**MOTOR COACH**  
INDUSTRIES

**SUBJECT: SAFETY RECALL OF ARVINMERITOR ADAPTER PLATE BOLT  
UNDER-TORQUE**

Ref.: **ARVINMERITOR NHTSA # 10E-014**  
**MCI NHTSA # 10V-199**  
**TRANSPORT CANADA #TC 2010-153**  
**MCI Service Bulletins 345 & 346**

### Inspect for Under-Tightened Hub/Rotor/Adapter Plate Bolts on Meritor Front Non-Drive Steer Axles and Tag Axles Equipped with Unitized Wheel Ends Installed on Motor Coach Industries (MCI) Coaches

#### Check Hub/Rotor/Adapter Plate Bolt Torque on the Unitized Wheel Ends

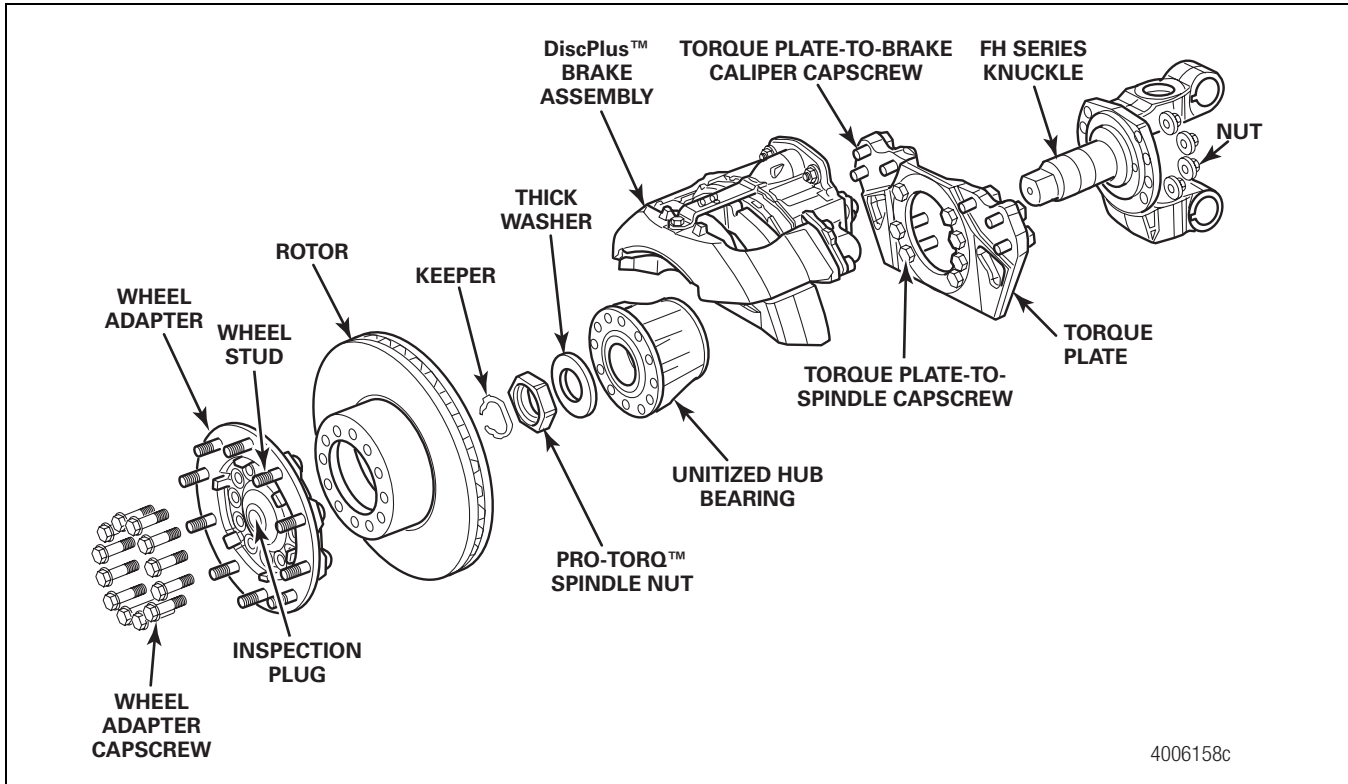
3. Use a torque wrench with a dial indicator to check hub/rotor/adapter plate bolt torque on all 12 bolts on each unitized wheel end. The bolt torque must not be less than 150 lb-ft (203 N•m). Record the torque on the Inspection Sheet included in this bulletin. 
  - **If hub/rotor/adapter plate bolt torque on any one of the 12 bolts on each unitized wheel end is less than 150 lb-ft (203 N•m):** Replace the bolt using ArvinMeritor part number 10X1711. Discard the bolts that were removed. Do not reuse old bolts. Record the bolt replacement on the Inspection Sheet included in this bulletin.

- **If any two or more bolts in the same bolt circle on a wheel end are less than 150 lb-ft (203 N•m):** Replace all 12 bolts on the untized wheel end using ArvinMeritor part number 10X1711. Remove, replace and tighten each bolt one at a time to maintain the correct clamp load on the wheel end. Discard the bolts that were removed. Do not reuse old bolts. Record the bolt replacement and torque in the Inspection Sheet included in this bulletin.

4. Use a click torque wrench to tighten all remaining bolts and any replacement bolts in a star pattern to  $275 \pm 25$  lb-ft ( $373 \pm 34$  N•m). Record the torque on the Inspection Sheet included in this bulletin. When you have tightened all of the bolts, recheck the torque of all 12 bolts in a star pattern. **T**
5. Mark a stripe on all of the tightened bolts. Use a different color than the color already used.

#### Check Hub/Rotor/Adapter Plate Bolt Torque on the Unitized Wheel Ends

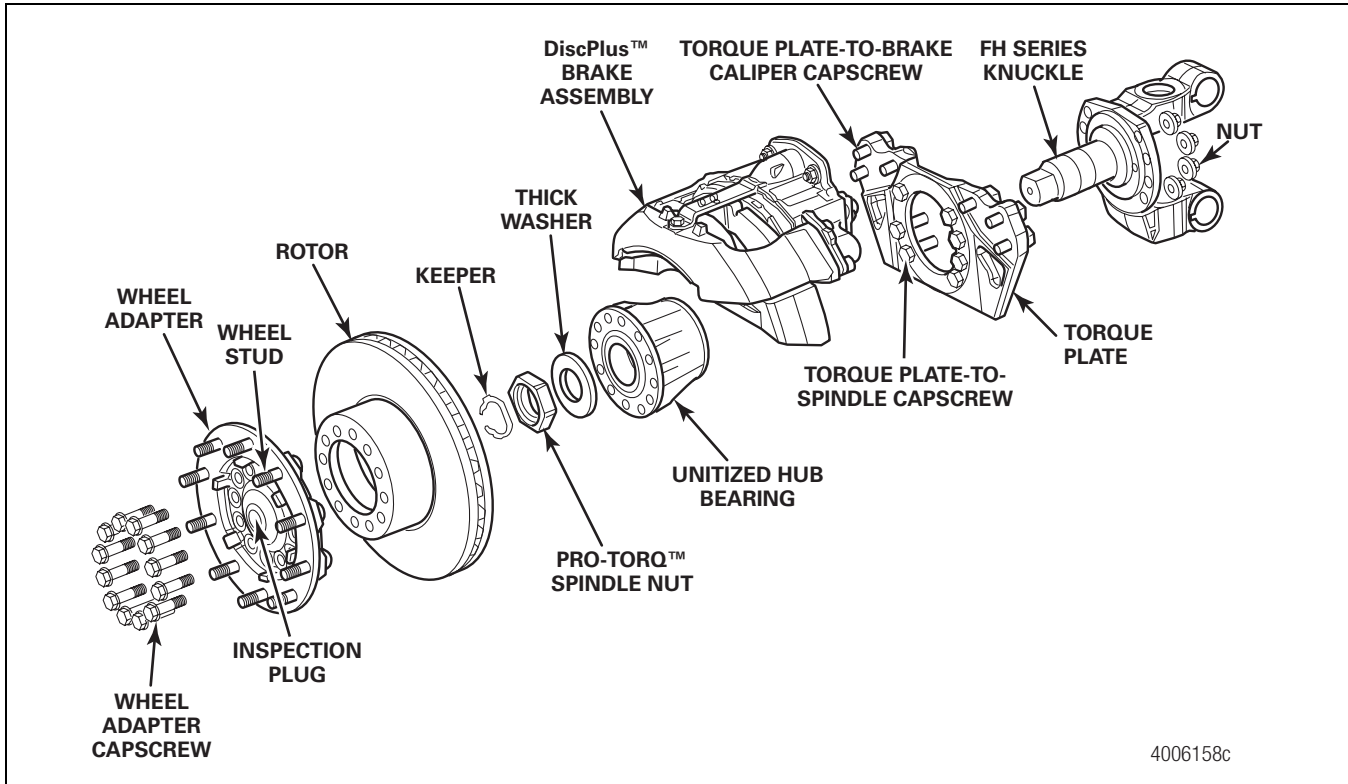
3. Use a torque wrench with a dial indicator to check hub/rotor/adapter plate bolt torque on all 12 bolts on each unitized wheel end. The bolt torque must not be less than 150 lb-ft (203 N•m). Record the torque on the Inspection Sheet included in this bulletin. 
  - **If hub/rotor/adapter plate bolt torque on any one of the 12 bolts on each unitized wheel end is less than 150 lb-ft (203 N•m):** Replace the bolt using ArvinMeritor part number 10X1711. Discard the bolts that were removed. Do not reuse old bolts. Record the bolt replacement on the Inspection Sheet included in this bulletin.

- **If any two or more bolts in the same bolt circle on a wheel end are less than 150 lb-ft (203 N•m):** Replace all 12 bolts on the untized wheel end using ArvinMeritor part number 10X1711. Remove, replace and tighten each bolt one at a time to maintain the correct clamp load on the wheel end. Discard the bolts that were removed. Do not reuse old bolts. Record the bolt replacement and torque in the Inspection Sheet included in this bulletin.

4. Use a click torque wrench to tighten all remaining bolts and any replacement bolts in a star pattern to  $275 \pm 25$  lb-ft ( $373 \pm 34$  N•m). Record the torque on the Inspection Sheet included in this bulletin. When you have tightened all of the bolts, recheck the torque of all 12 bolts in a star pattern. **T**
5. Mark a stripe on all of the tightened bolts. Use a different color than the color already used.
